**Addendum Number:** 02

**Owner:** Crawford County Highway Department

**Project Name:** New Shop & Office

**Project Number:** 0210855.00

**C3.1-A**  
ADDENDUM SHEET

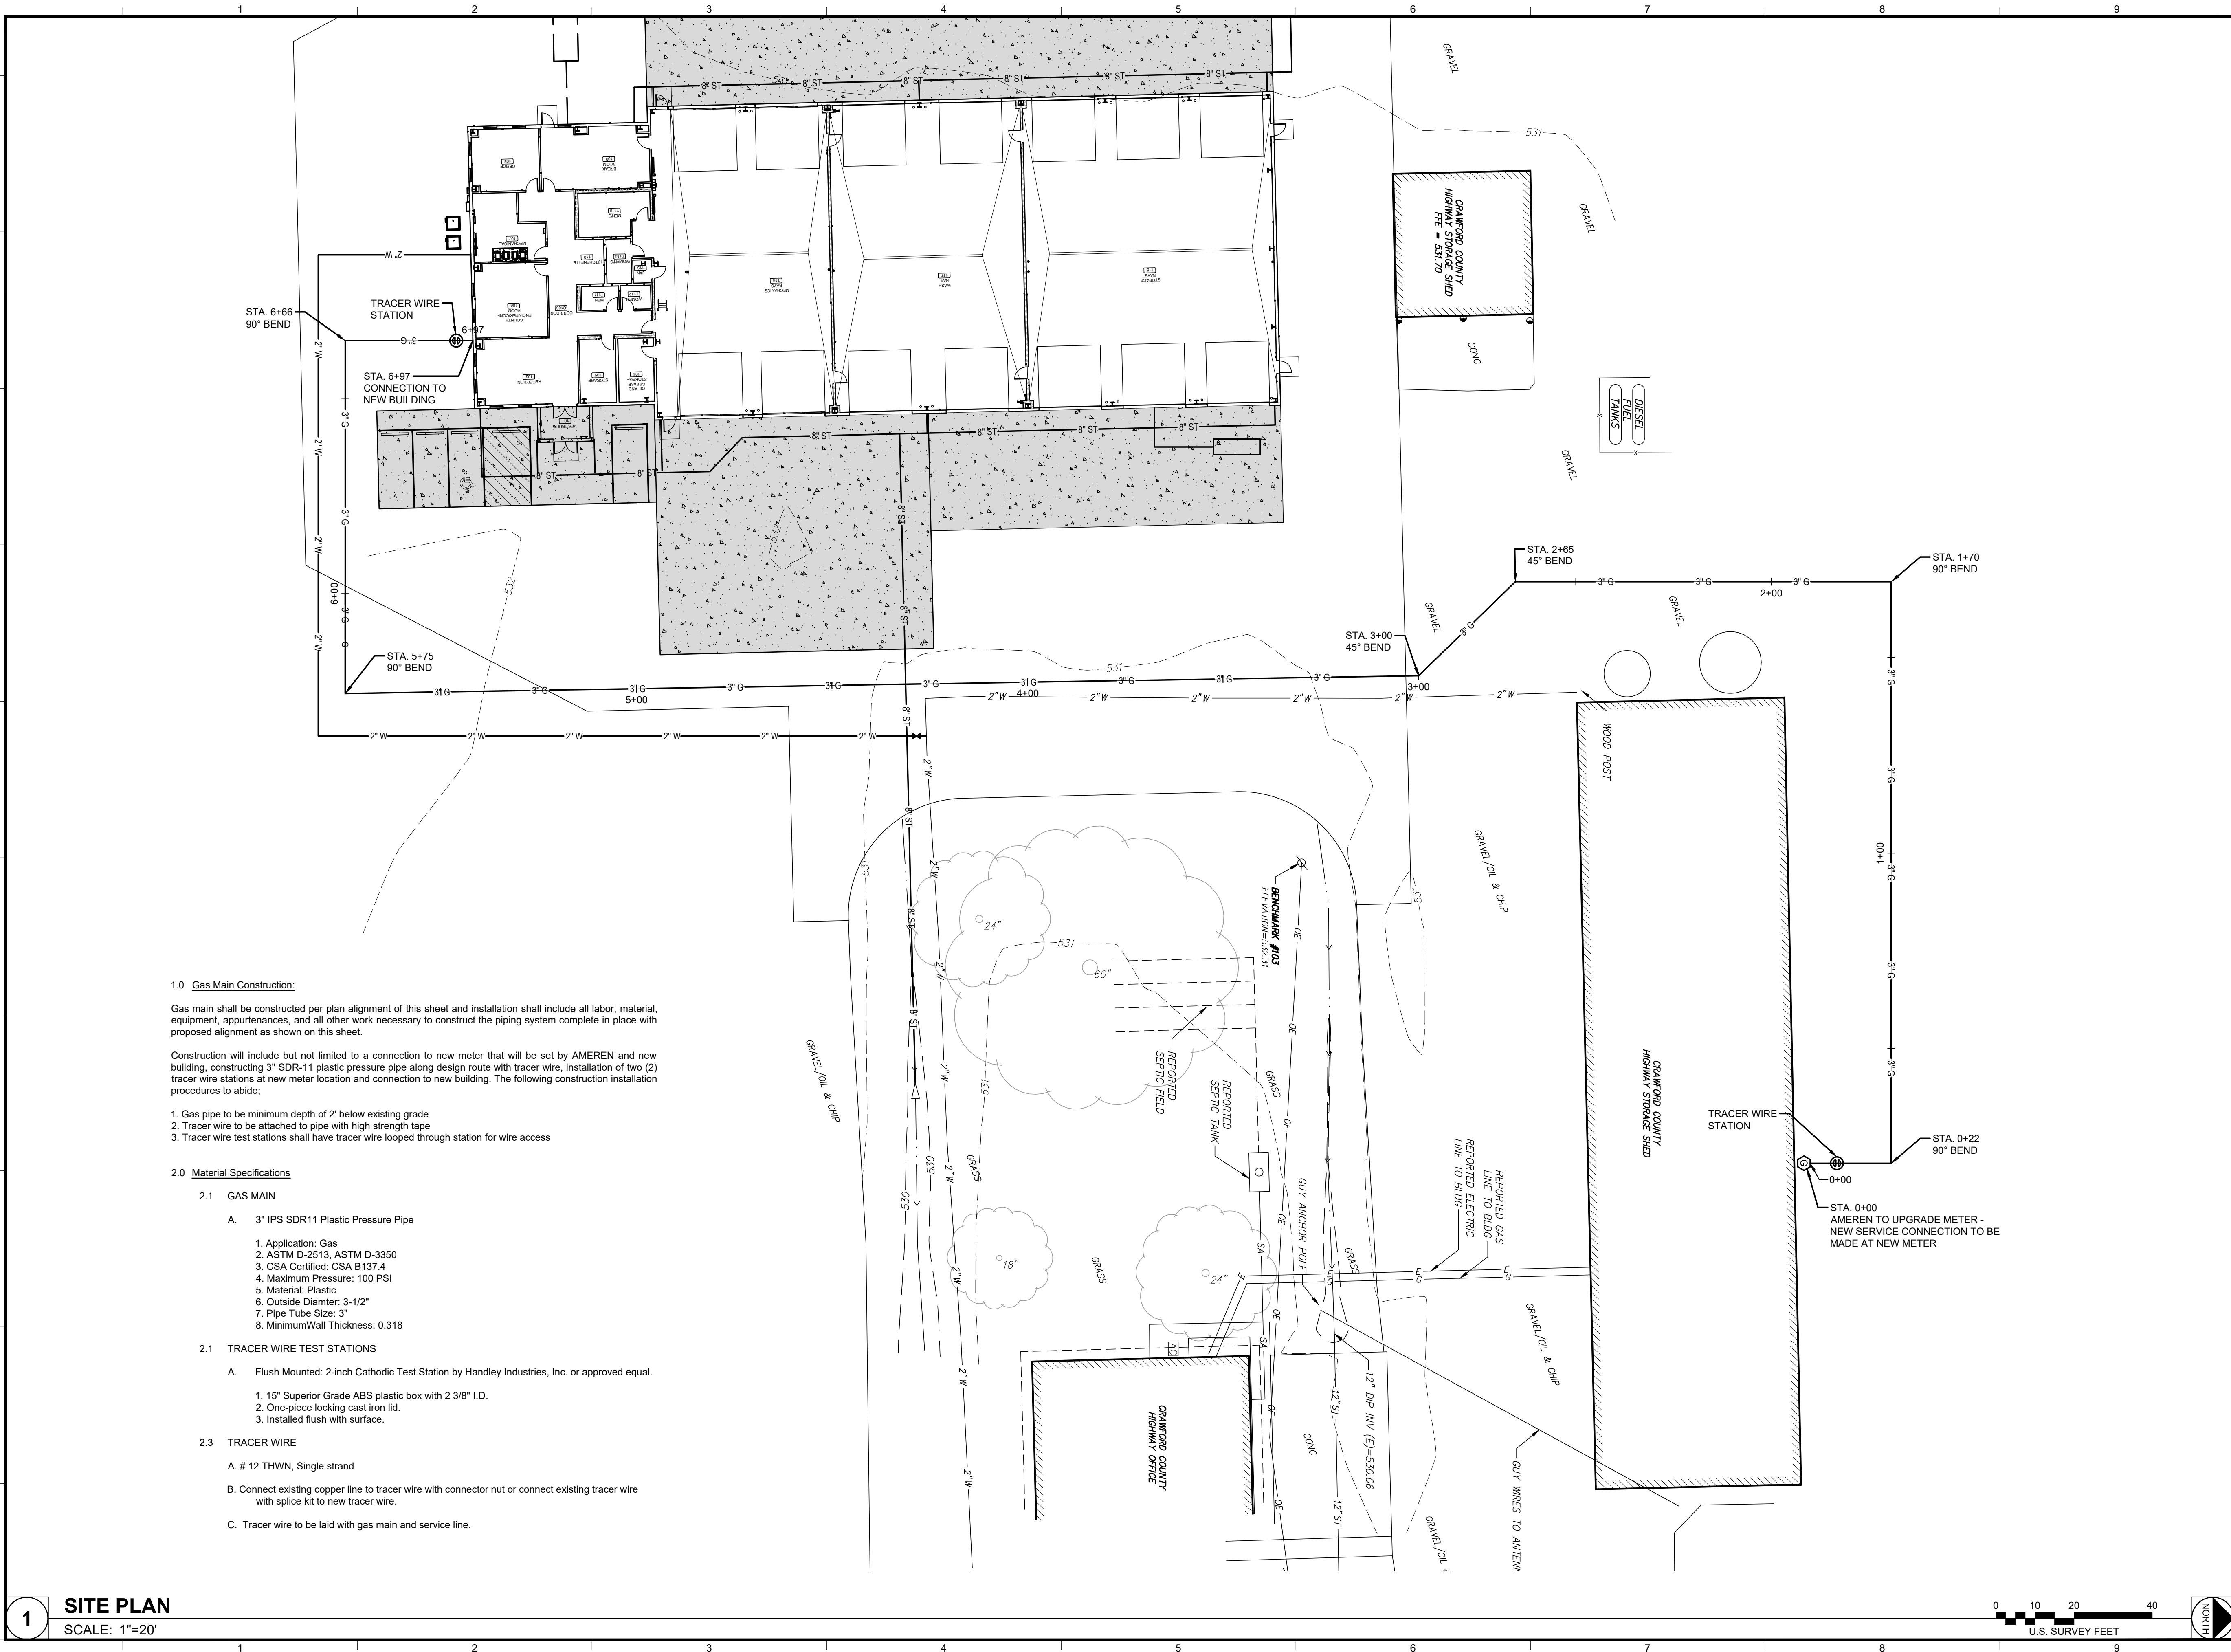
- a. This sheet shall be added to the drawing set. It shows the connection point for the gas service. The contractor shall include all labor, material, and equipment required to install the new gas line from the meter to the proposed building.

## A7.1

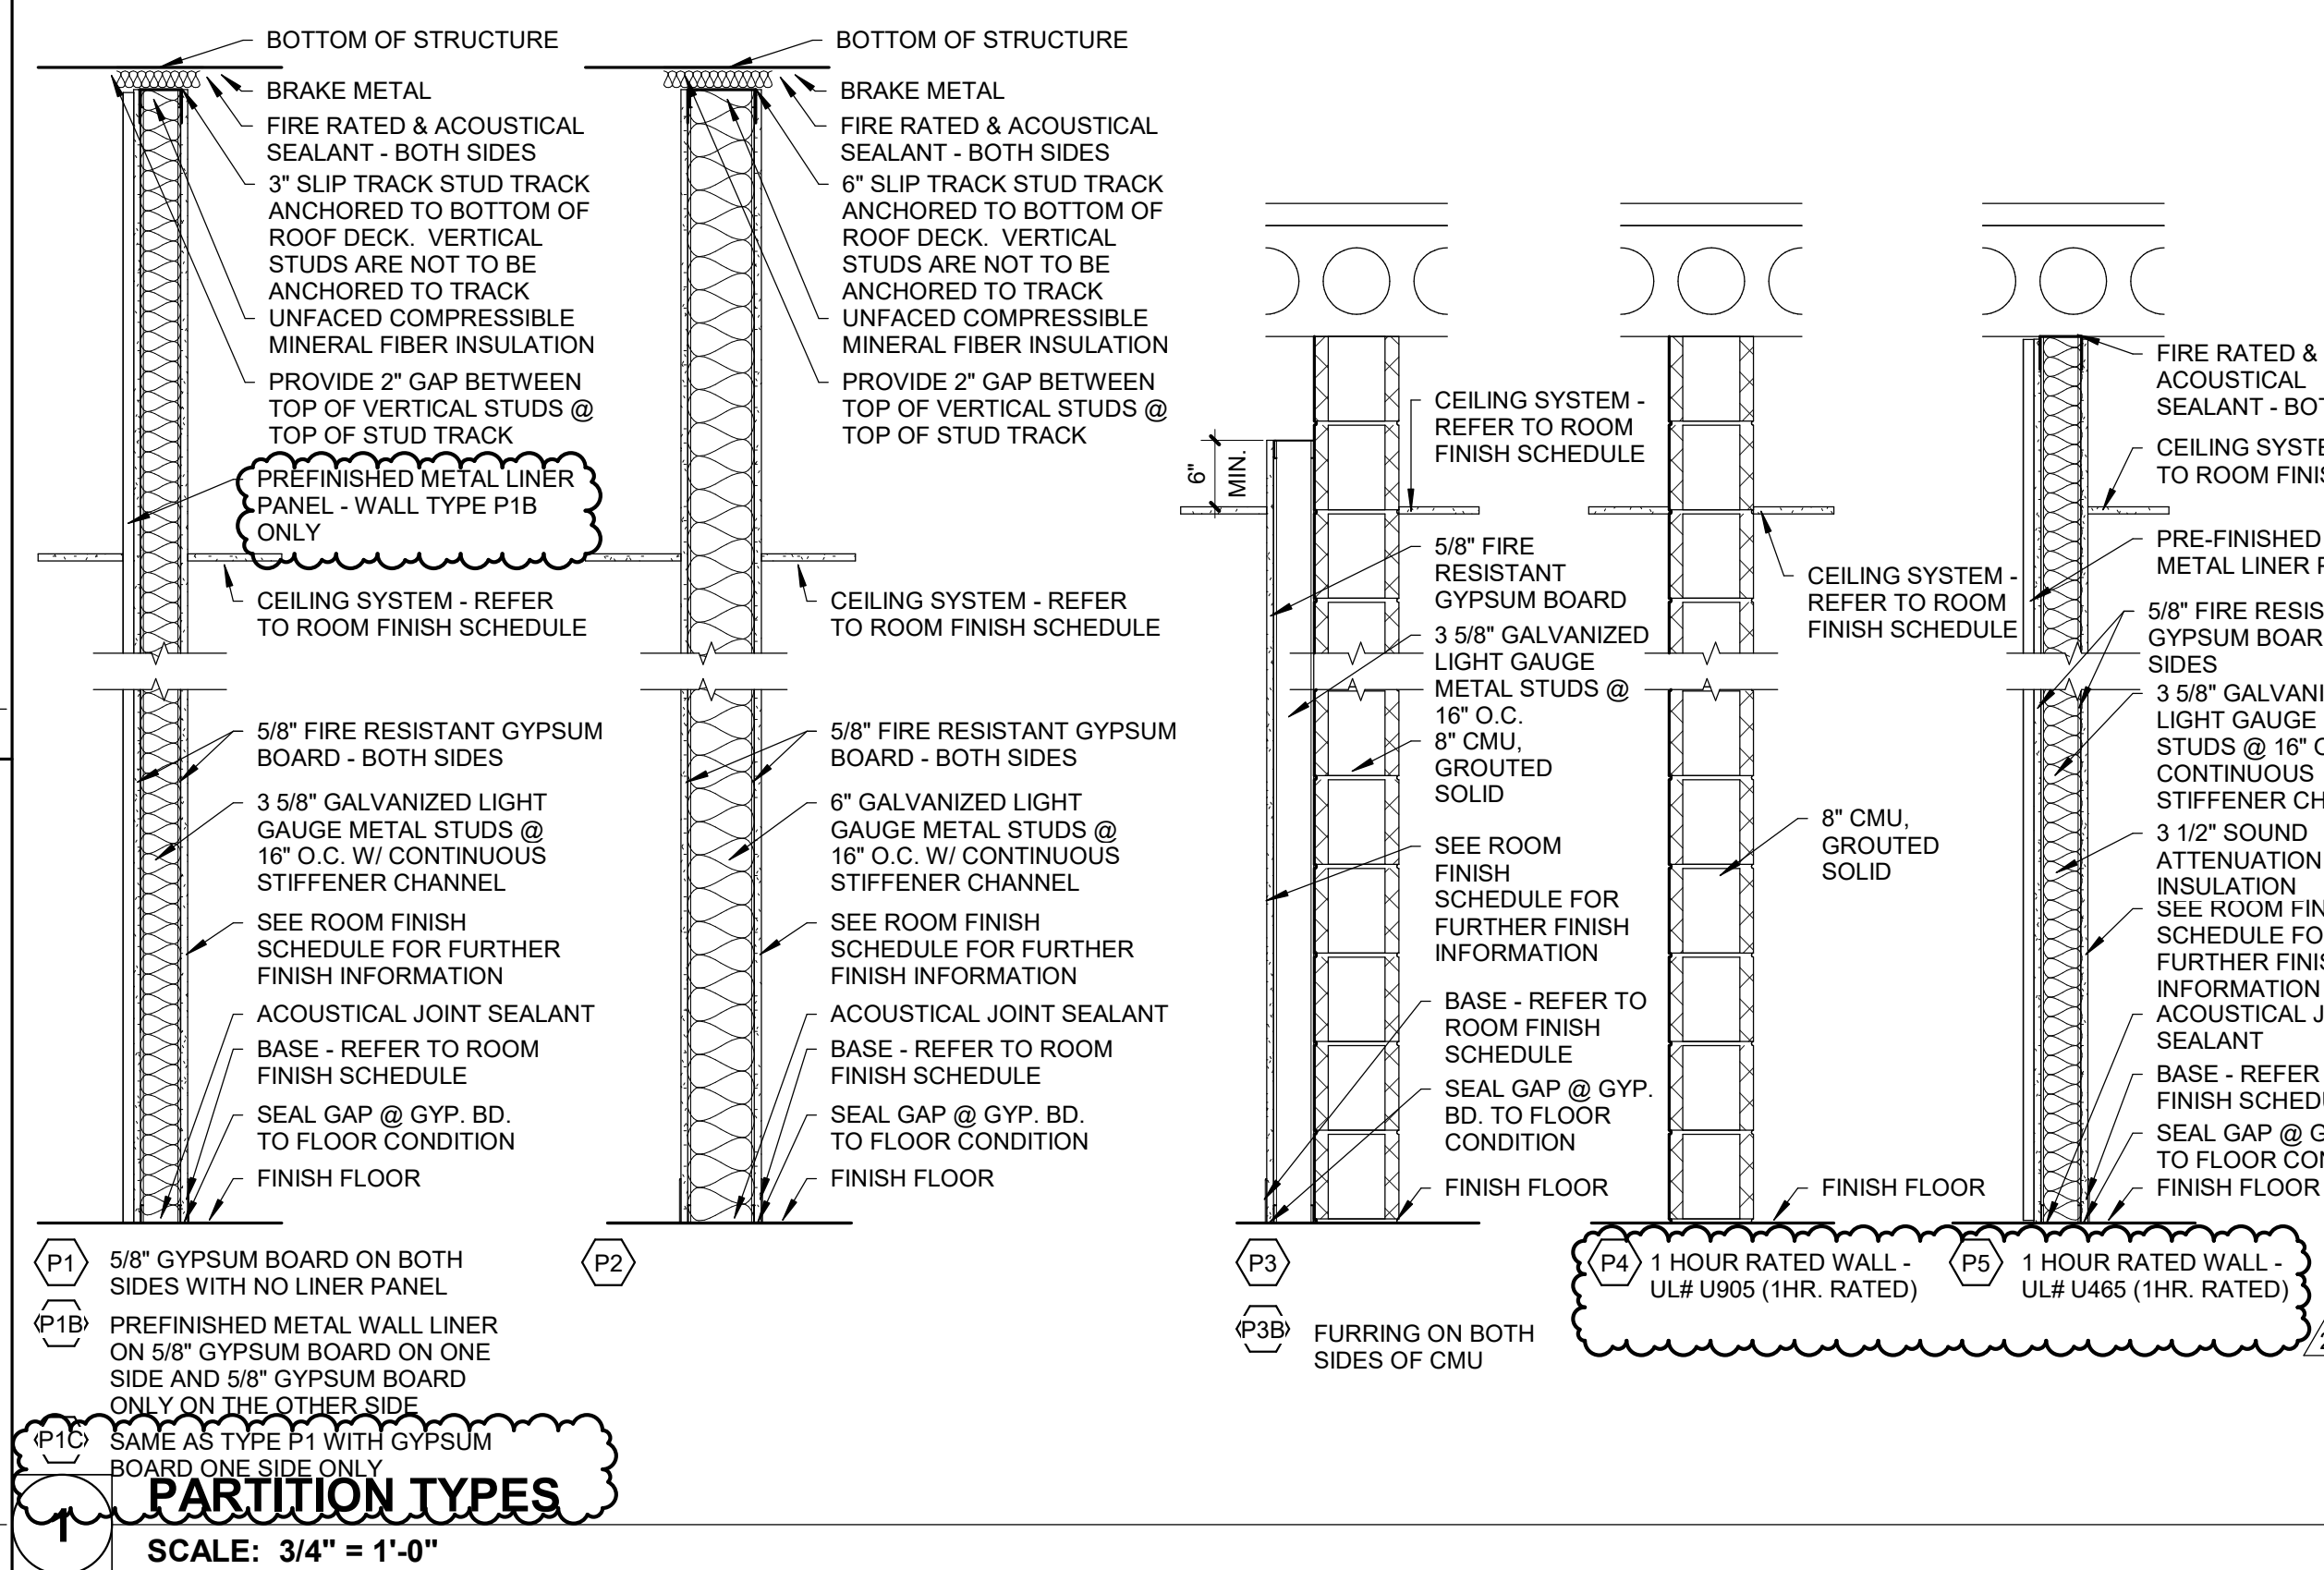
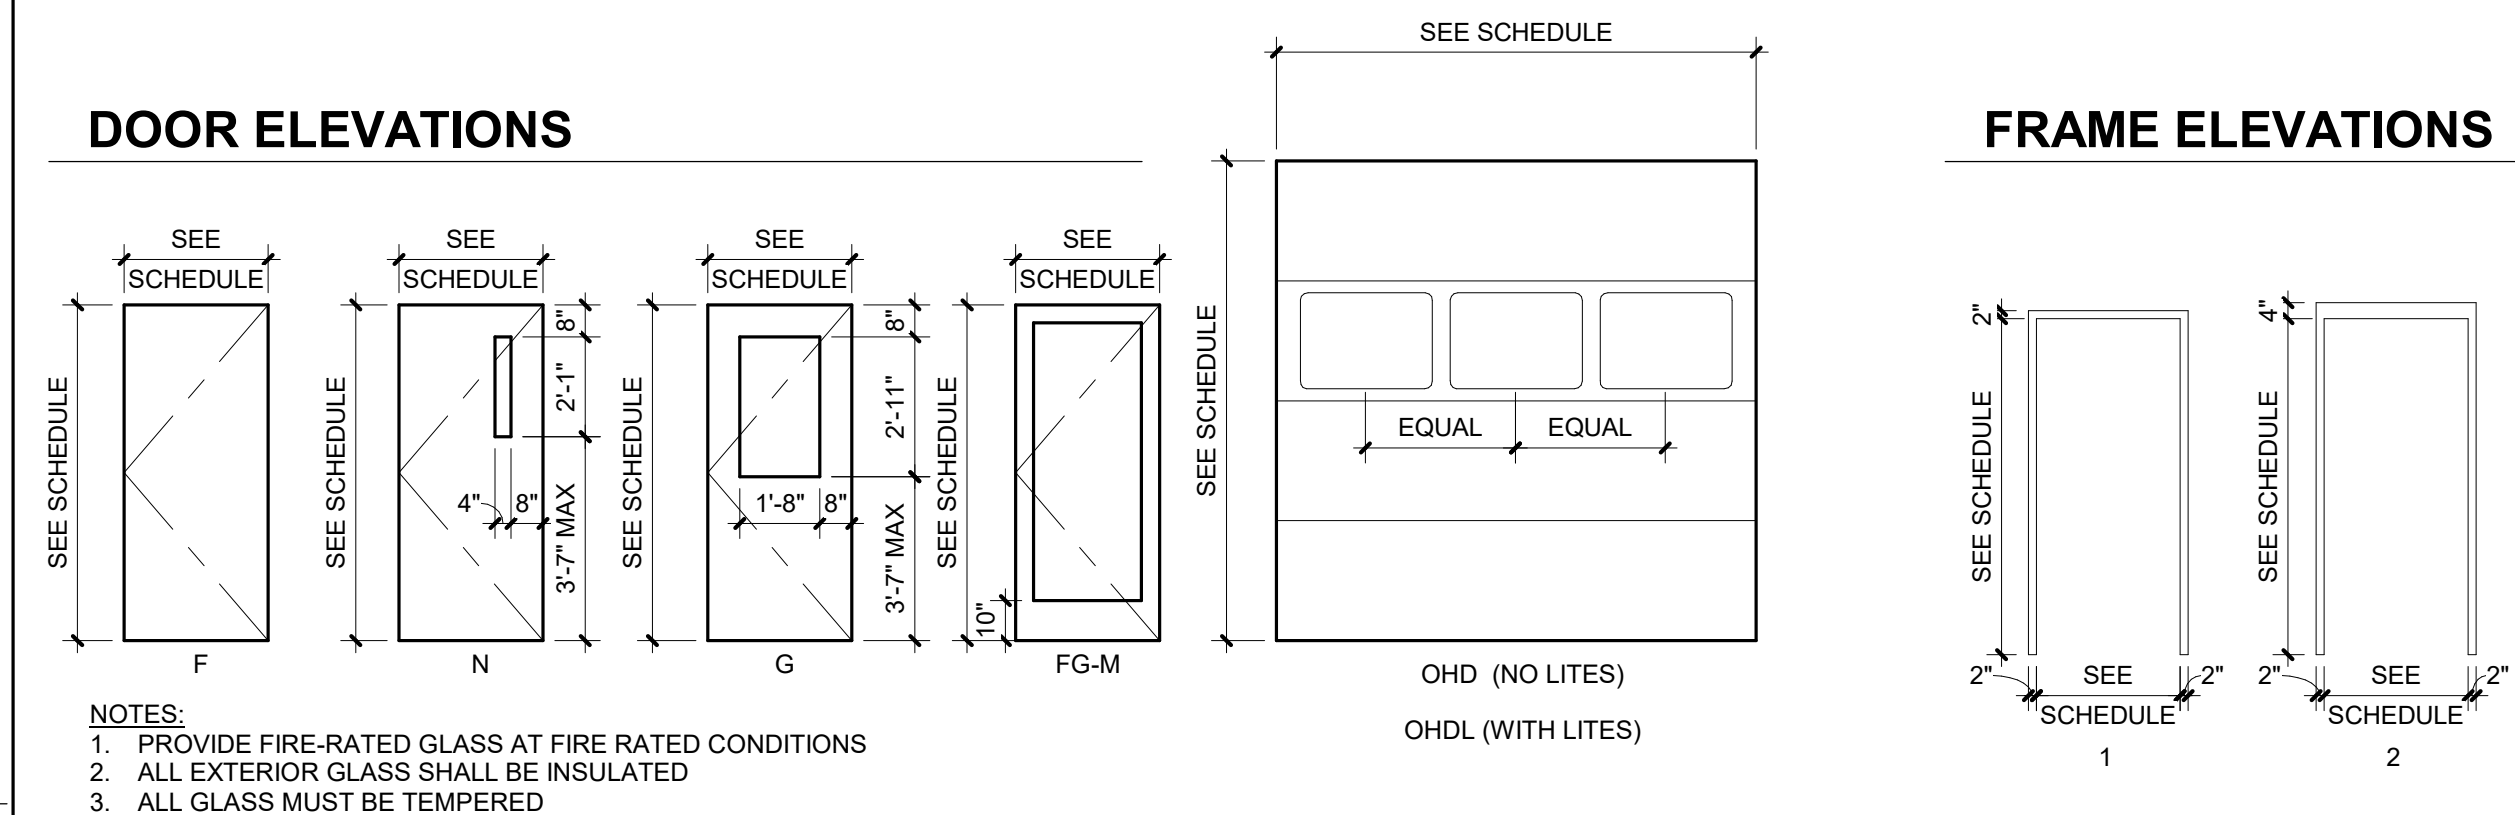
- a. Remove detail 2 – this detail is not needed.
- b. All fire rated walls shall follow head-of-wall detail UL #HW-D-0927.
- c. UL assembly types have been added to P4 & P5.

- d. Partition type P6 has been updated to show a liner panel on one side only. The liner panel shall be added to the side facing the Mechanic's Bay.
  - e. Partition type P1C has been added.
5. A7.2 – DOOR AND WINDOW DETAILS
- a. Details 1, 2, and 3 have been revised to show the 2 ½" metal studs and 5/8" gypsum board on the interior side of the girts.
6. A8.1 – INTERIOR ELEVATIONS AND ENLARGED PLANS
- a. The walls located around the columns shall be partition type P1C.
7. M6.1 – RADIANT FLOOR SCHEDULE
- a. The tube diameter and spacing may be changed based on delegated design by the radiant floor heating system manufacturer to provide a heating density of 22.3 BTH/SF as scheduled. Pumps P-3 and P-4 shall be sized to provide the required pressure differential and flow rate of the radiant floor design.
